CALGARY PLANNING COMMISSION

October 18, 2018, 1:00 PM
IN THE COUNCIL CHAMBER
Members

- 7.1.1 Policy Amendment and Land Use Amendment in Bridgeland-Riverside (Ward 9) at 1018 McDougall Road NE, LOC2018-0059, CPC2018-0968
- 7.1.2 Development Permit in Bridgeland-Riverside (Ward 9) at 1018 McDougall Road NE, DP2018-3108, CPC2018-1130

DRAWING
 PROPOSED SITE PLAN
 DRAWN BY: MW JOB NO.: 1720
 CHECKED BY: TC SHEET NO.: 20 R/06
 SCALE: As Indicated
A1.01

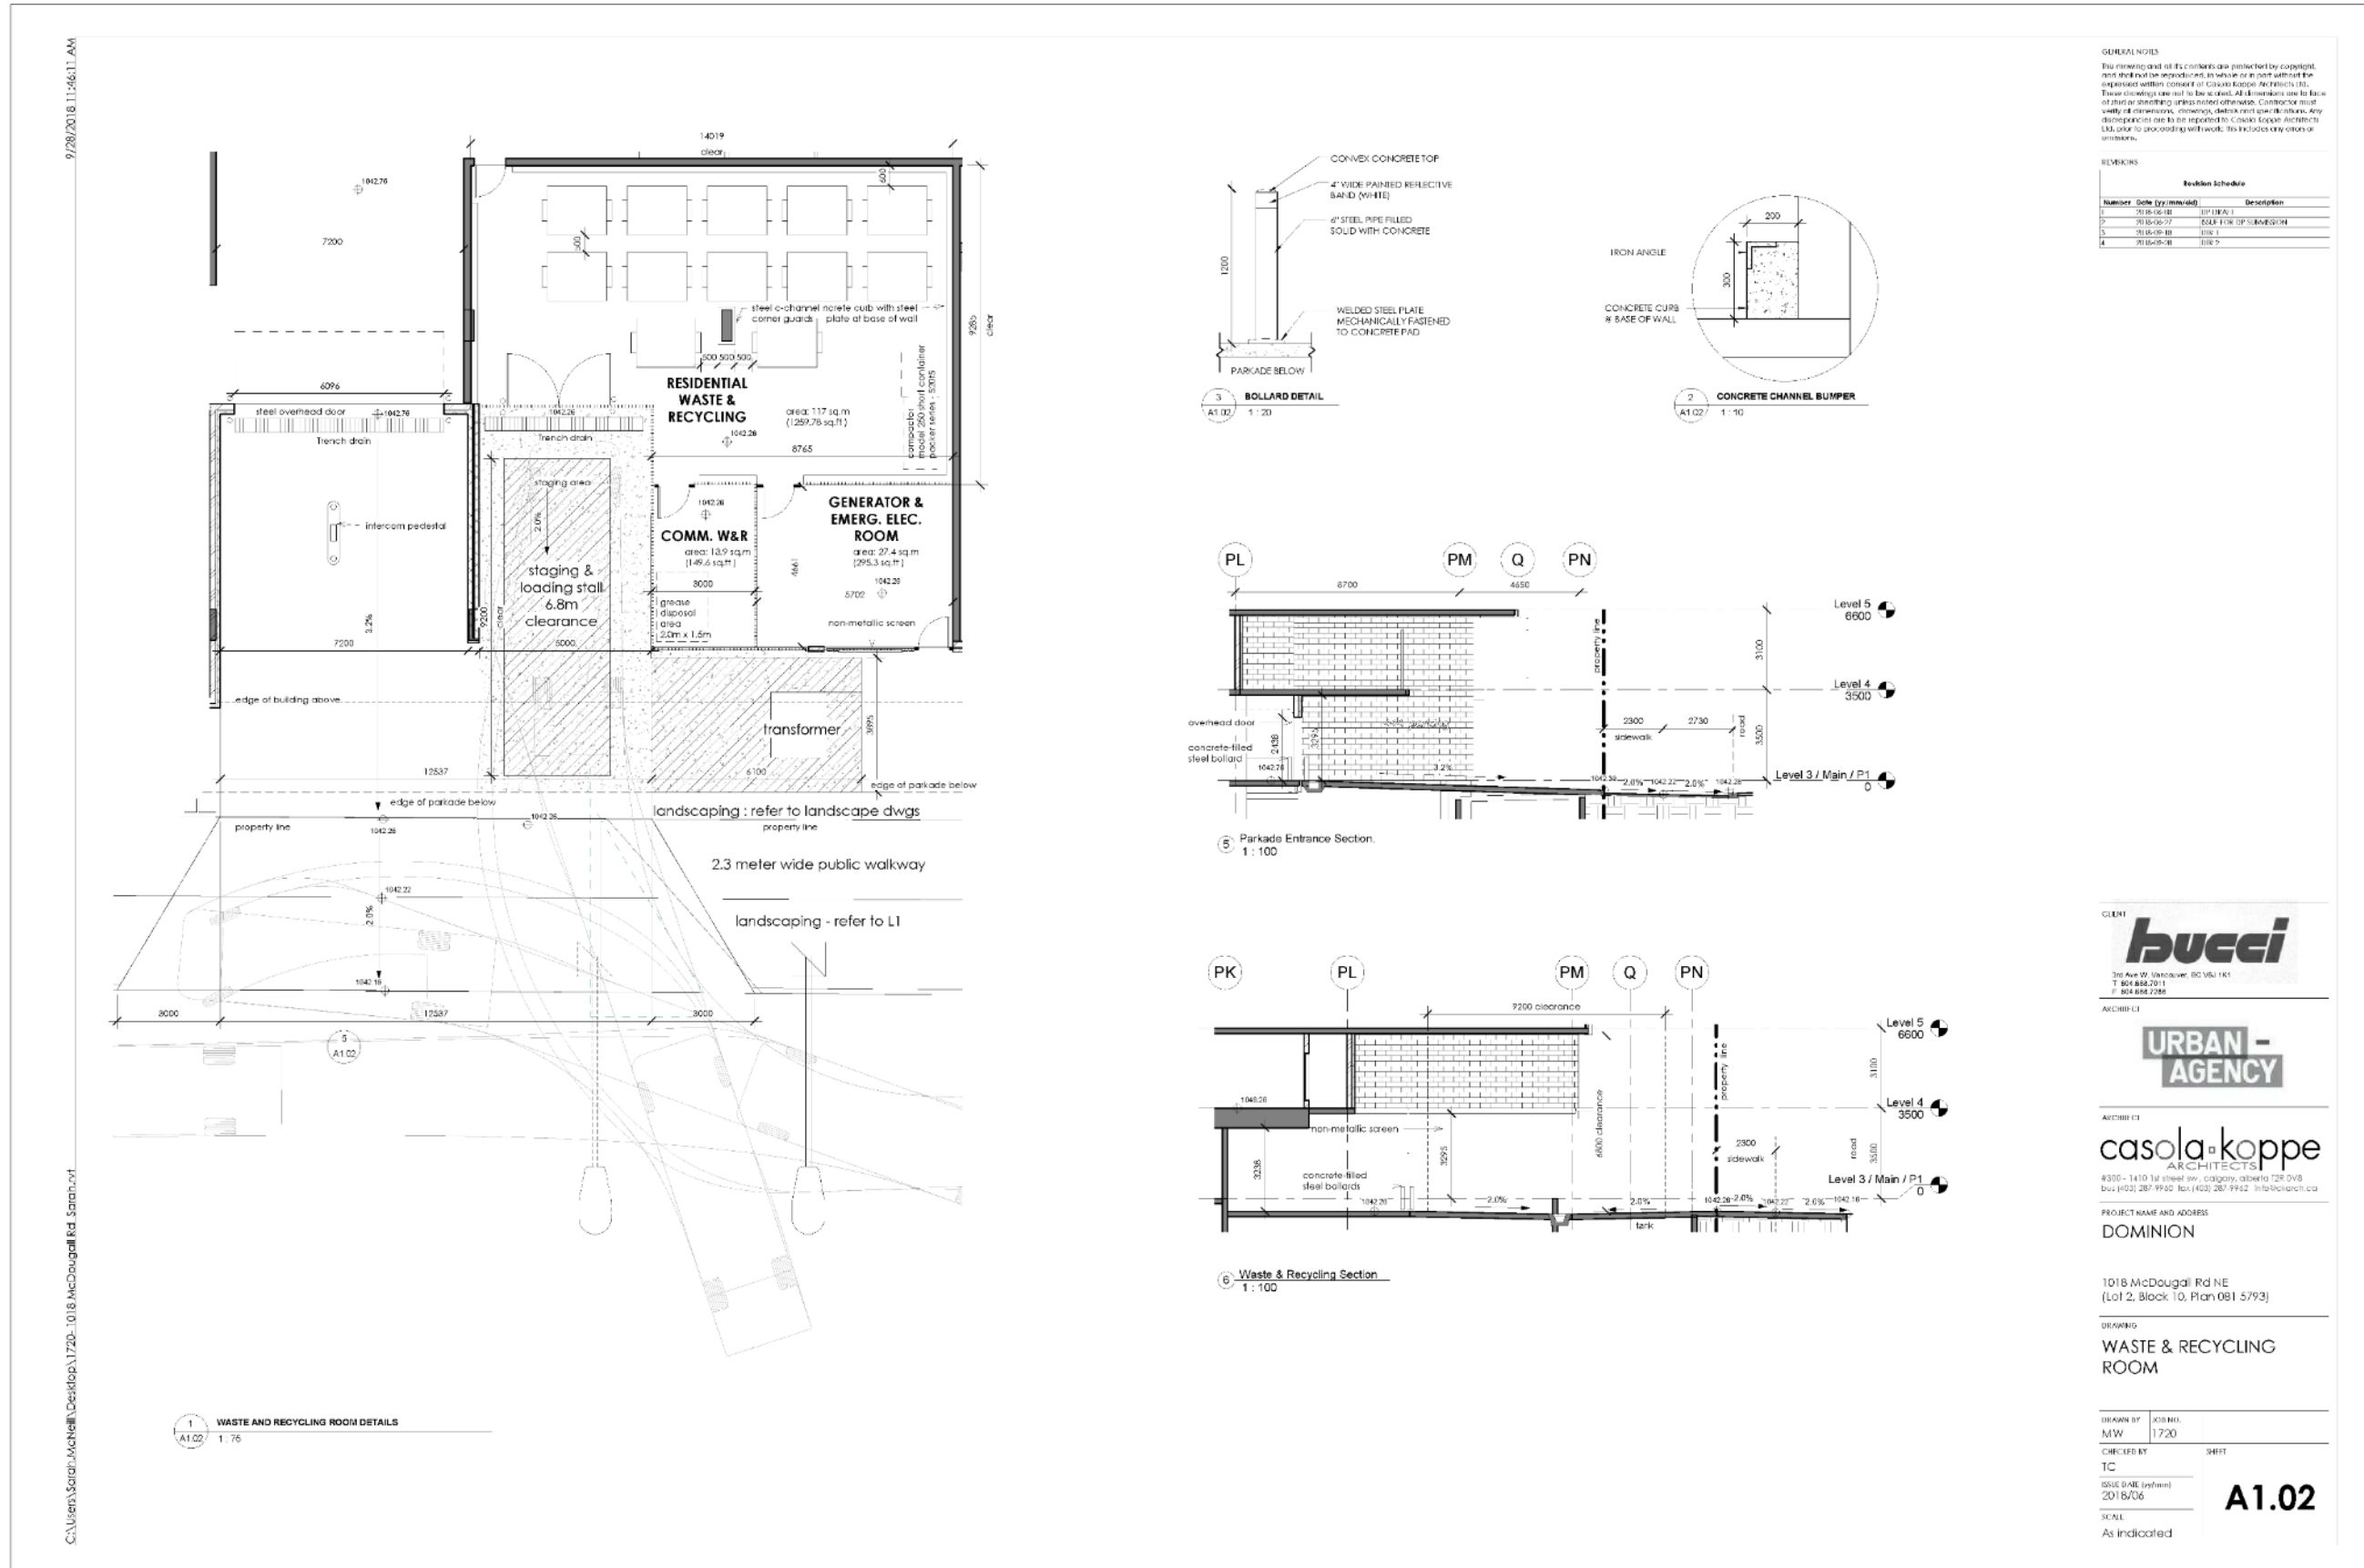
18. Amend the Proposed Site Plan (A1.01), Site Plan (L1), and Planting Plan (L2) to show a continuous tree trench for the proposed boulevard trees along 9 Street NE, ensuring the trench extends a minimum of 2 metres past the tree grate to allow root growth away from the tree trunk. The trench design is to be approved by Calgary Roads.

A2.02

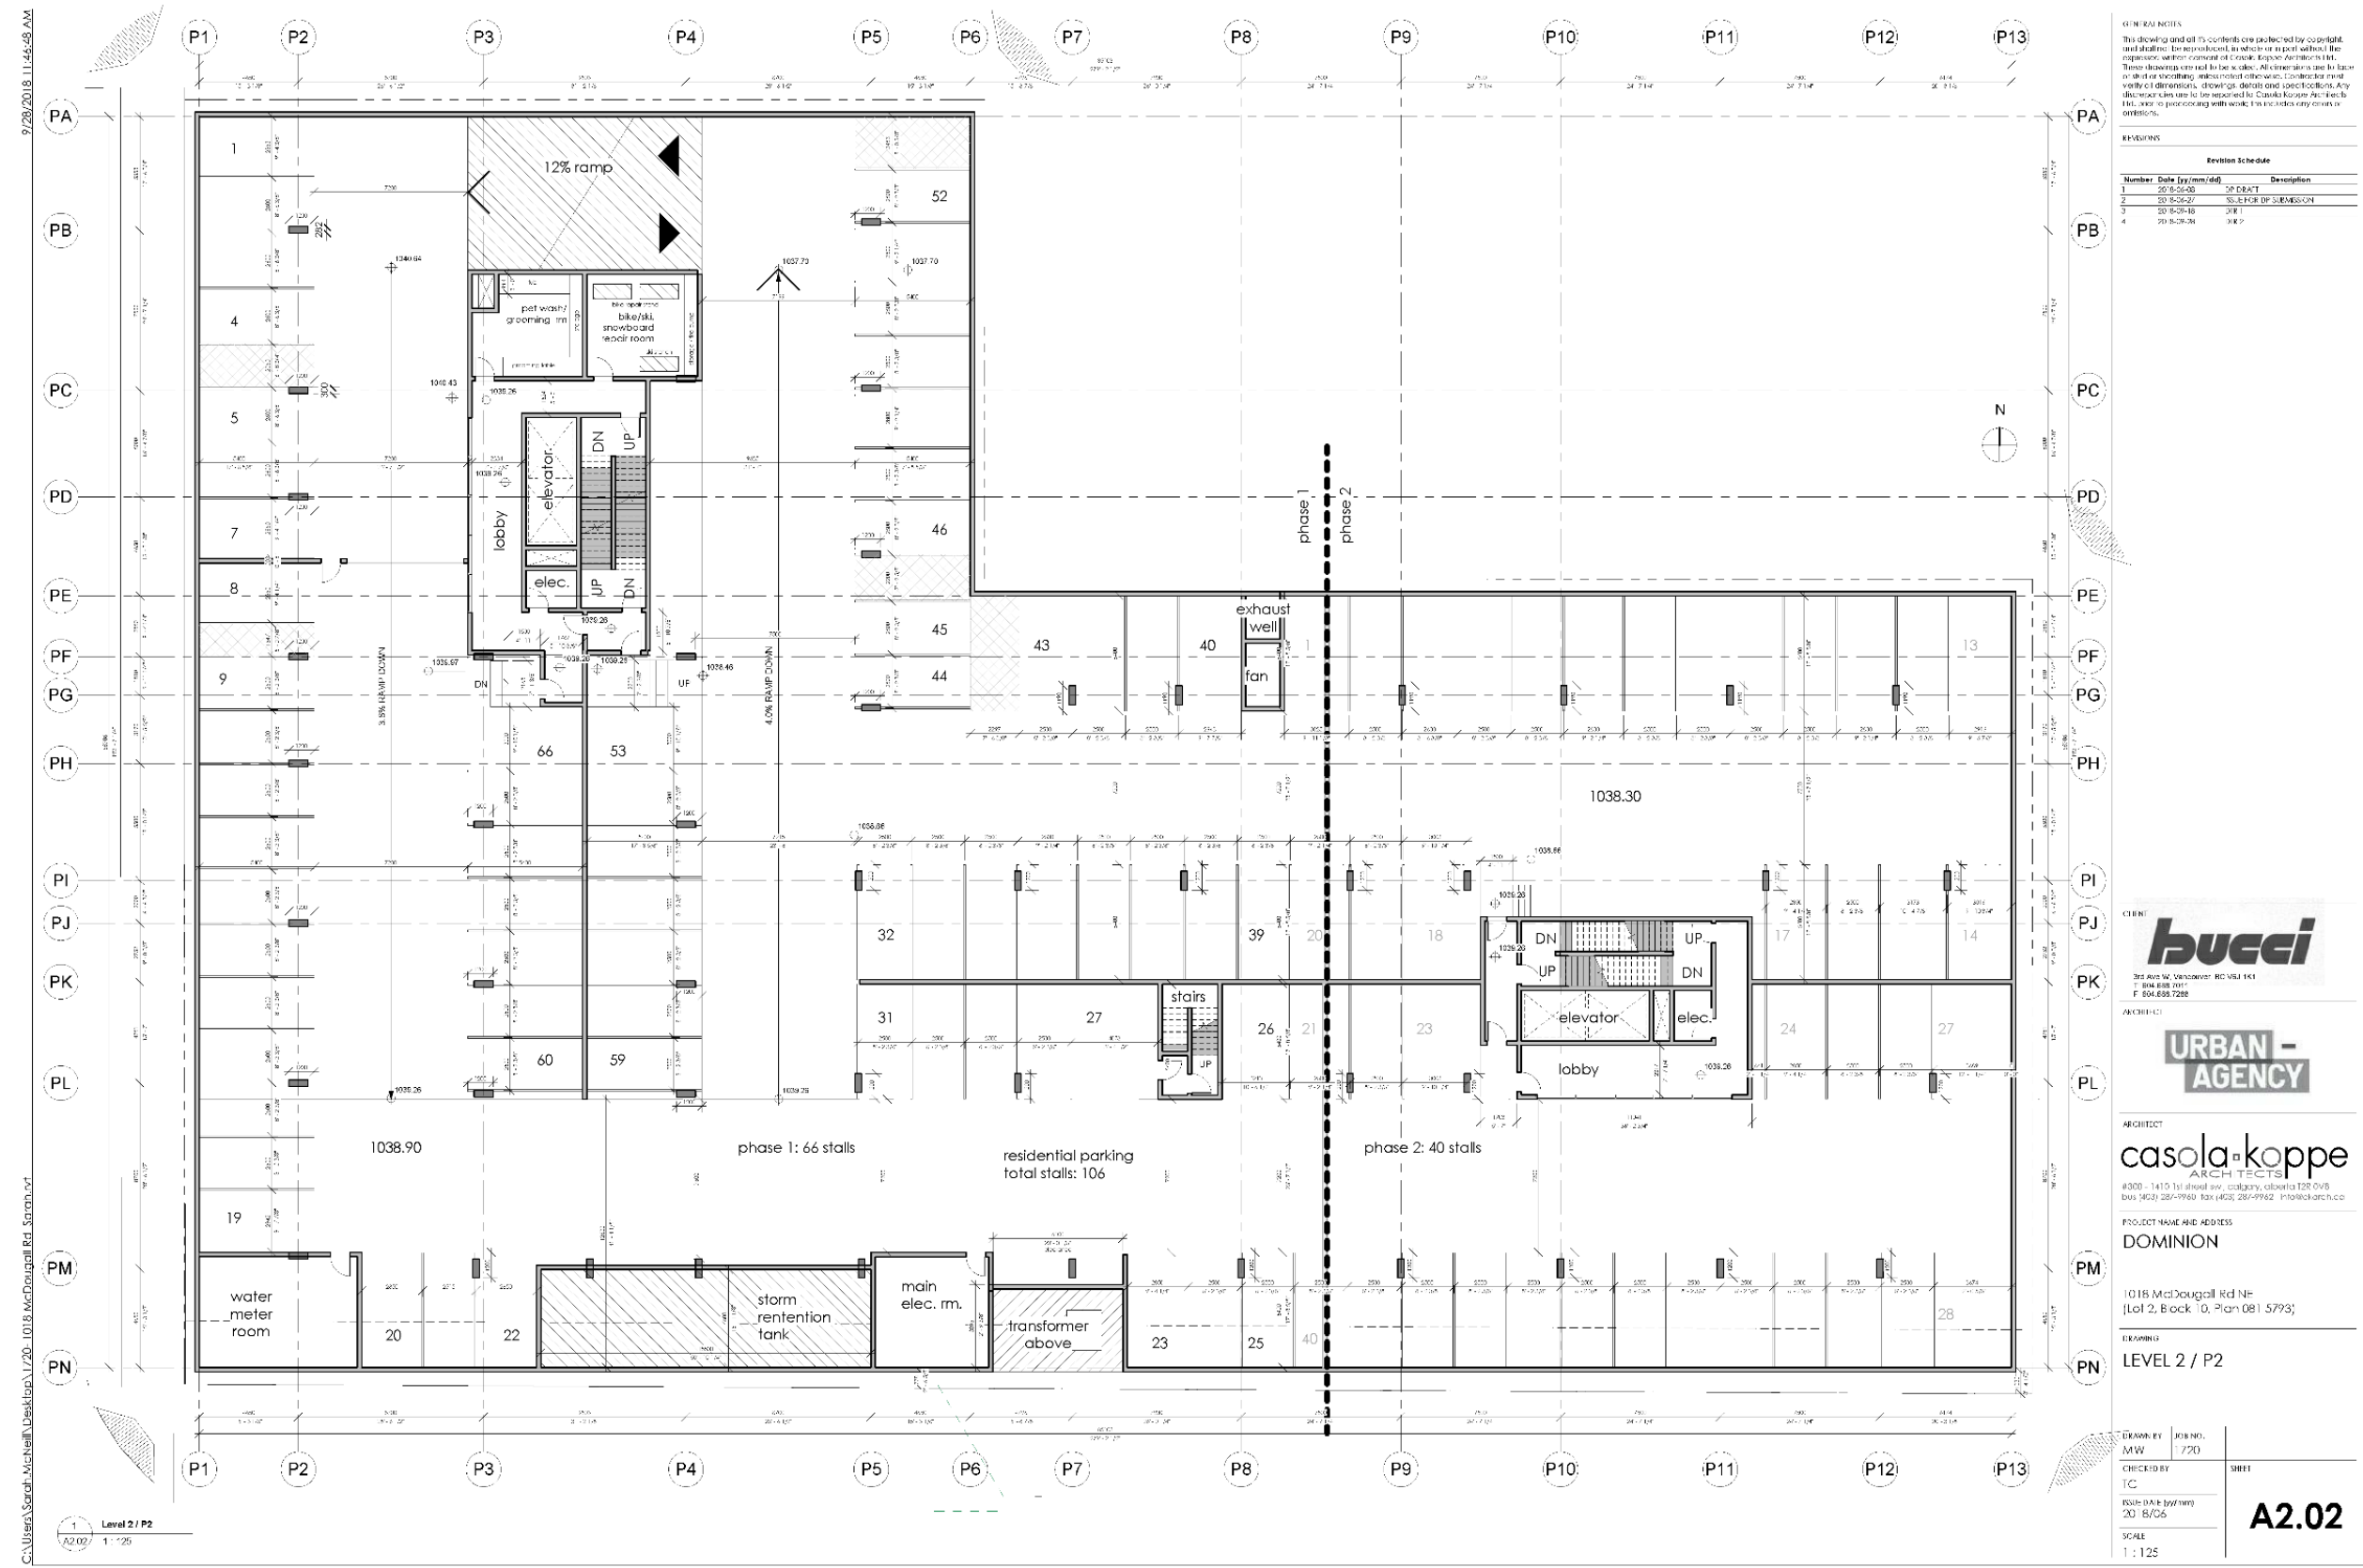
6. Amend drawing A2.02, P2 parkade plan to indicate stalls 1-7 to be Visitor/Commercial stalls.
7. Amend drawing A2.03, P3 parkade plan to indicate stall 21 to be Visitor/Commercial stalls.
8. Amend the total proposed parking stall count in the "Commercial Area Information" table on A2.09 to reflect the additional commercial/visitor stall count (44 stalls) and to break up the parking requirements for Dwelling Units vs Live Work Units.
9. Amend the "Zoning Compliance Table" on A1.01B to reflect the changes to commercial/visitor parking stalls and parking requirements for Dwelling Units vs Live Work Units.
